MILITARY SPECIFICATION

INTERCOMMUNICATION STATIONS

NAVAL SHIPBOARD

This amendment forms a part of Military Specification MIL-I-24078(SHIPS), 14 September 1964.

Figure 3- Schematic diagram for remote loudspeaker station.

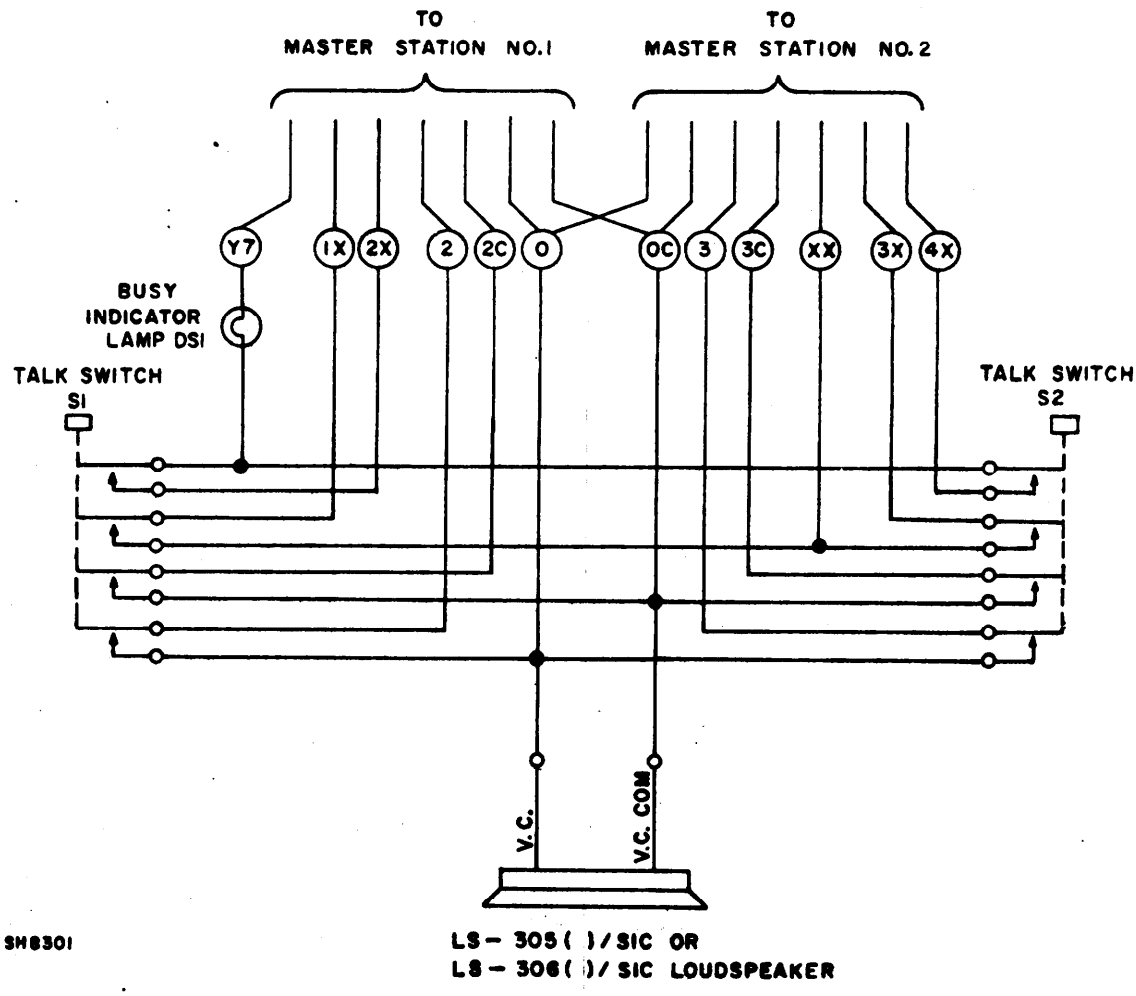
"3.24.5 Operation of equipment with remote loudspeaker stations.- Intercommunication stations furnished under this specification shall be capable of performing in the manner specified herein when used with one or more remote loudspeaker stations. The remote loudspeaker station shall include: (1) an LS-305/SIC(IC/SAA) or LS-306/SIC(IC/SAG) loudspeaker manufactured in accordance with requirements of MIL-A-20222 for loudspeaker type IC/SAA or IC/SAG; (2) two talk switches; and (3) a busy indicator lamp. The remote loudspeaker station circuitry will be in accordance with figure 3.

Add attached figure 3.
